ARLINGTON COUNTY, VIRGINIA
OFFICE OF THE PURCHASING AGENT

INVITATION TO BID NO. 22-DPR-ITB-479

ADDENDUM NO. 1

Arlington County Invitation to Bid No. 22-DPR-ITB-479 for Construction of Alcova Heights Park Renovations is amended as follows:

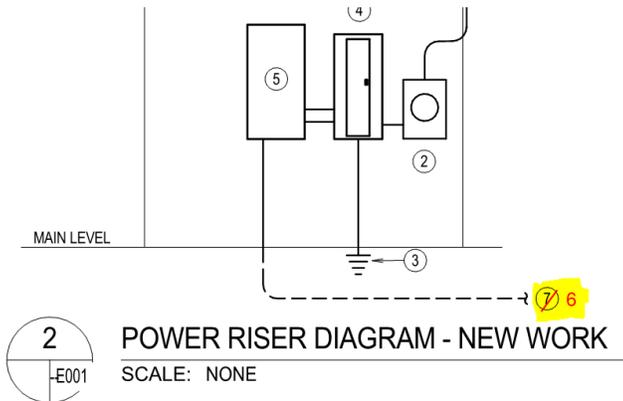
Question 20: Detail 2 on sheet E001 in the architectural drawings refers to a note 7. However, there is no keynote 7 on this detail. Additionally keynote 6 doesn't appear to be used. Please clarify.

Answer 20: **Note #7 should be note #6. See snip below**
